AGENDA
PLANNING COMMISSION
116 WEST NEEDLES
BIXBY, OKLAHOMA
January 21, 2014 **6:00 PM**

**MINUTES
PLANNING COMMISSION
116 WEST NEEDLES
BIXBY, OKLAHOMA
November 18, 2013 6:00 PM**

To: Bixby Planning Commission
From: Erik Enyart, AICP, City Planner
Date: Wednesday, November 13, 2013
RE: Report and Recommendations for:
Final Plat of "Woodcreek Office Park" – Sack & Associates, Inc. (PUD 47-C)

*To: Bixby Planning Commission
From: Erik Enyart, AICP, City Planner
Date: Thursday, November 14, 2013
RE: Report and Recommendations for:
Preliminary Plat of "Seven Lakes III"*

SP1

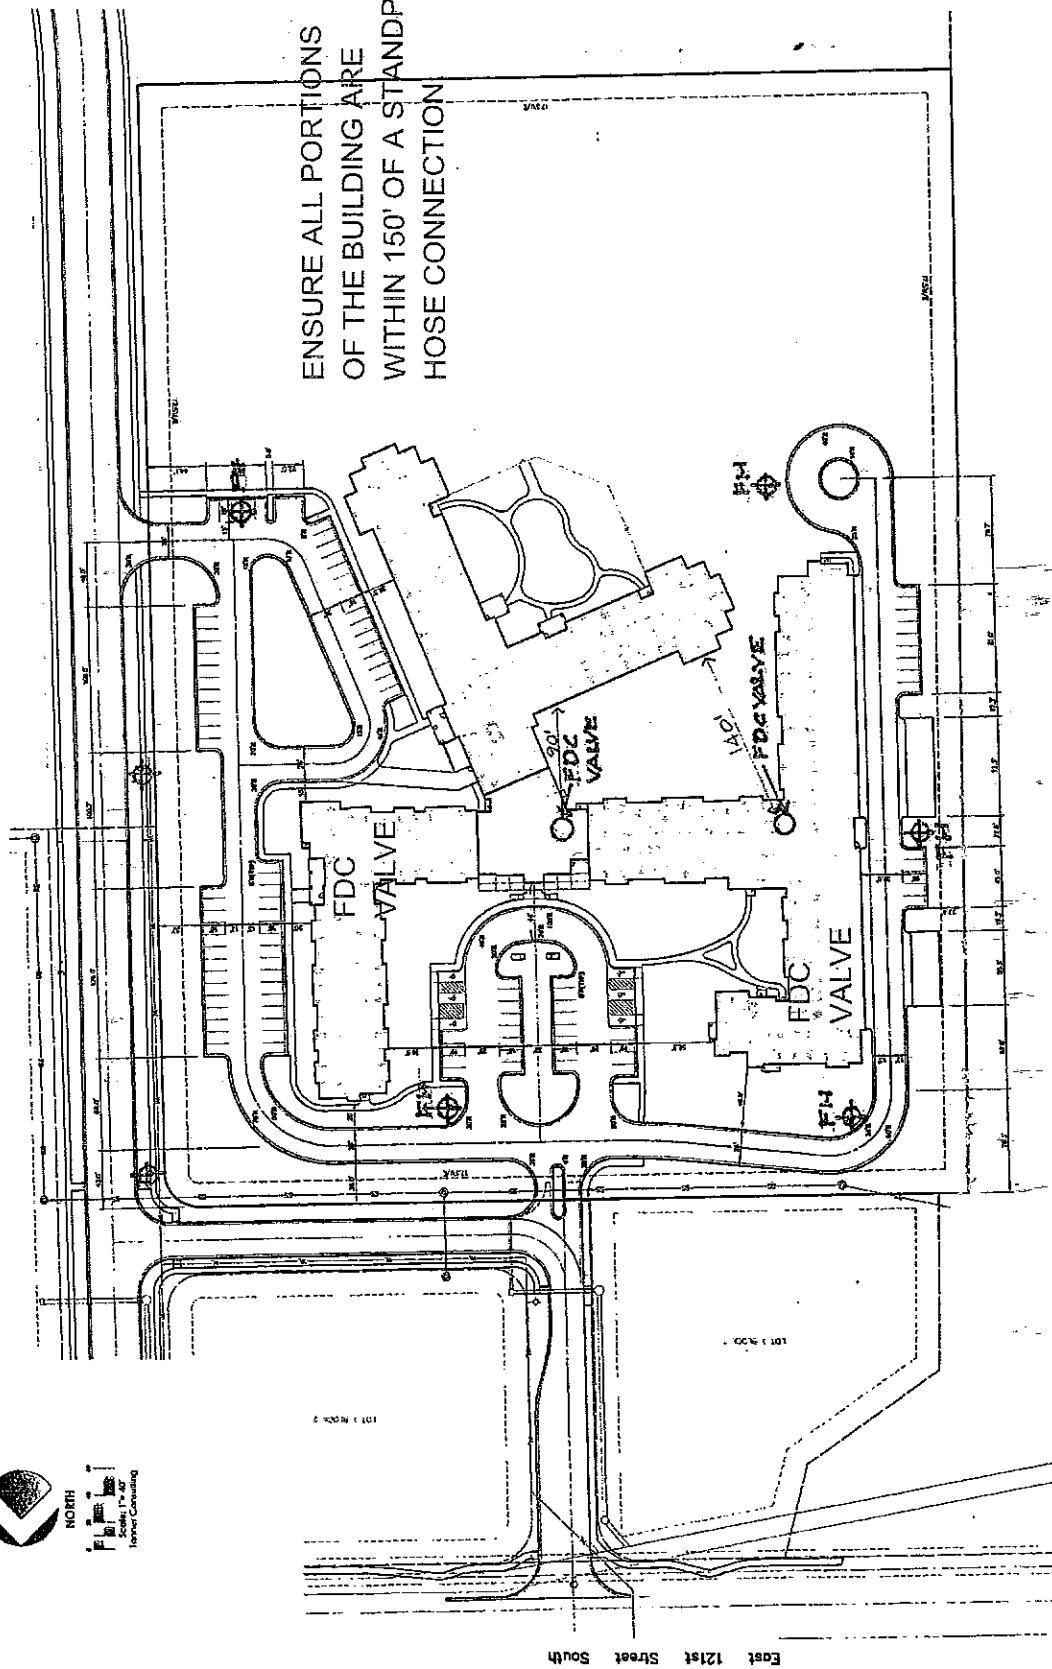
The submitted plan-view Site Plan drawing consists of "Detail Site Plan" drawing SD02 by Tanner Consulting, LLC. It does not represent the entire lot of record, as required by the Site Plan application, so the Applicant has submitted a rescaled version on January 03, 2014 in satisfaction of this requirement. PUD 76 allows a maximum of 160,000 square feet of floor

Parking & Loading Standards. The "Detail Site Plan" drawing SD02 indicates a total of 88 off-street parking spaces. However, Staff counted 96 surface lot parking spaces and 42 garage parking spaces, for a total of 138 off-street parking spaces. This number should be corrected. By interpretation of the SD02 drawing in comparison to the elevations drawings, 28 of those garage spaces compose most of westerly side of the first floor of the westernmost north-south wing.

14. The "Detail Site Plan" drawing SD02 indicates a total of 88 off-street parking spaces. However, Staff counted 96 surface parking spaces and 42 garage parking spaces, for a total of 138 off-street parking spaces. This number should be corrected.

30. On site plan drawing SD02, please identify the symbols which appear to be the "Monument Sign" and the "Directional Sign" per A2.08.
31. The "Directional Sign" (approximately 8.75 square feet in display surface area) should be reduced to not exceed the three (3) square feet maximum display surface area per Zoning Code Section 11-9-21.C.3.k, or an amendment to PUD 76 may be sought to relax applicable signage restrictions.
